DATE: February 5, 2014

AGENDA ITEM # 3

FROM: Sierra Davis, Assistant Planner

SUBJECT: 13-SC-18 – 171 Del Monte Avenue

REAR ELEVATION

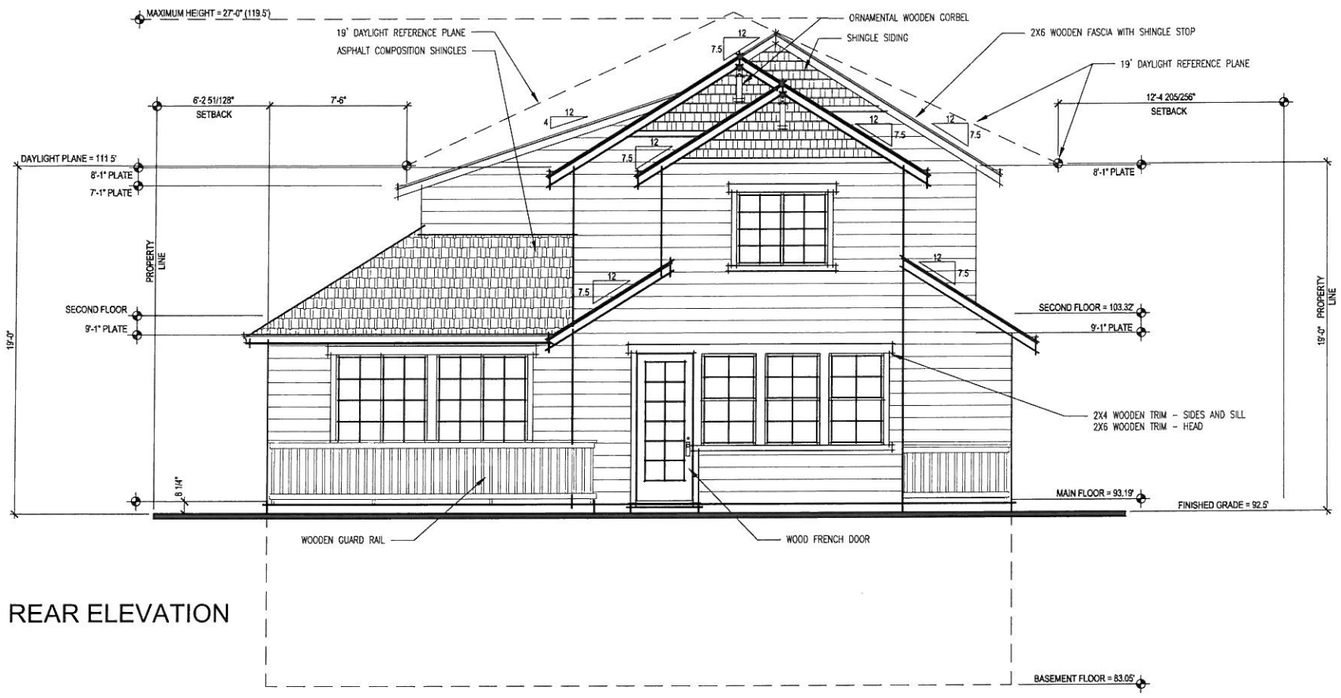
The Design Review Commission minutes from the December 4, 2013 meeting reflect a direction to add windows on the Mercedes Avenue elevation. The intent was to break up the massing of the house. A window has been added in bedroom three on the front elevation and a window at the rear of the house in the stairway.

The rear facing window is in the stairway and is approximately 55 feet from the rear property line; it would not result in a privacy issue because viewing down into neighboring properties would be difficult. The window in bedroom no. 3 is on the southwest corner of the house facing the corner of Del Monte Avenue and Mercedes Avenue which is a more public area and would not result in a significant privacy impact.

Although the follow up email we received noted the request for additional windows along Mercedes Avenue, it was my understanding that the additional windows were requested along the East side of the home, specifically in the Kids' Room and the stairwell. These windows have been added, along with the requested window on the front elevation at the second floor.

FRONT ELEVATION

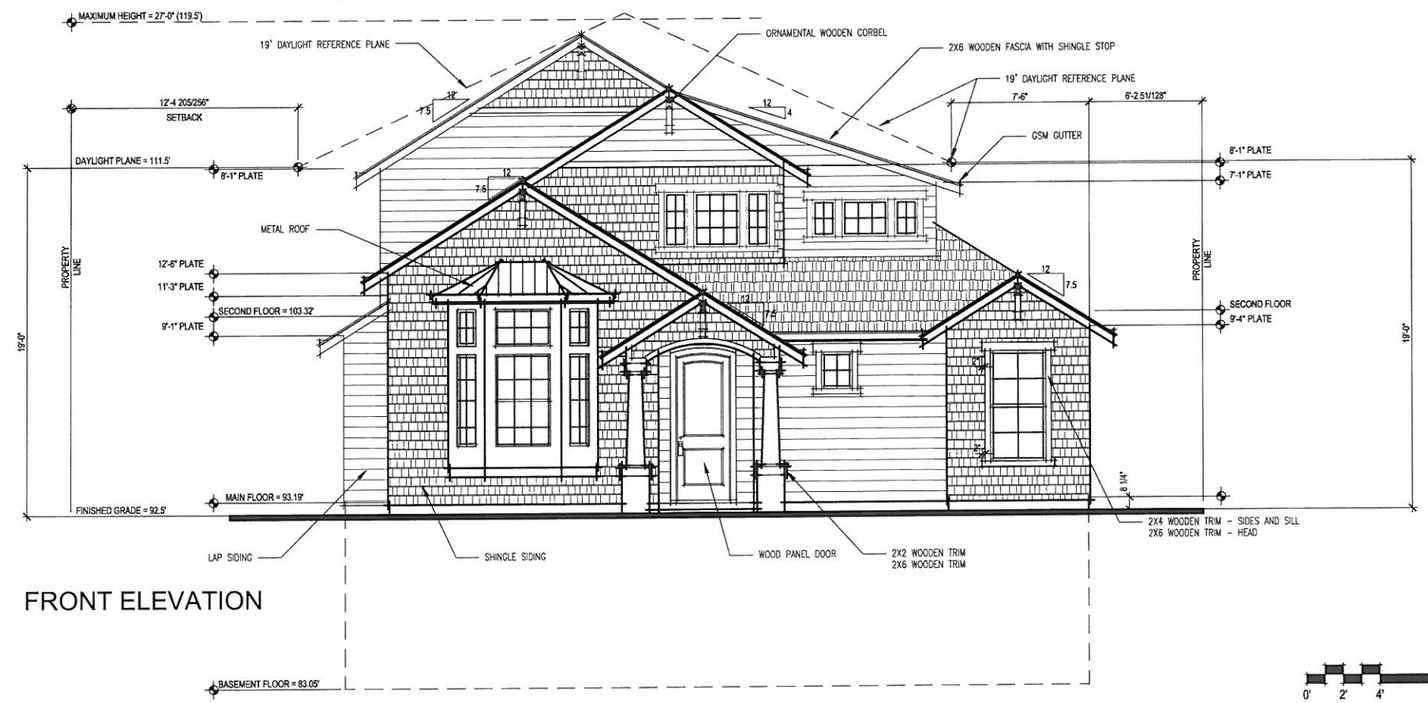
1. Reduce the massing of the living room and bay window size;
2. Reduce the bulk of second story; and
3. Consider adding windows on the Mercedes Avenue elevation.

The massing and scale of the bay window and entry element have been reduced proportionally. The bay window is still a prominent architectural element, but the overall size has been reduced from an eight foot wide element to a six and one-half-foot wide element. The front entry element was reduced from 12 feet in height to 11 feet because the roof line is tied into the gable over the living room element. The entry element has also been narrowed because of the lower height from eight-and-one-half foot wide element to a six-foot wide element.

The Commission also gave direction to address the bulk of the second story. The front facade has been reorganized to center the window in the front gable on the second story and added a window in bedroom three to break up the massing of the wall. The pitch of the roof has been reduced from 7.5:12 to 7:12 which reduces the height of the structure by one foot.

1. Reduced the roof pitch from 7.5:12 to 7:12;
2. Lowered the living room element by one foot;
3. Reduced bay window and entry element; and
4. Added windows to the front and back of the house.

- Reduced the Roof Pitch
- Reduced Living Room / Dining Room plate height by 1' (-9% reduction)
- Reduced Bay Window by 1'-3" in height, 1'-9" in width, and 6" in depth (-48% volume / 30% elevation)
- Added windows, Front Elev. in Bed 3, Rear Elev. in the stairs, and Right Elev. in the Kid's Room
- Revised Front Porch Size and Column details
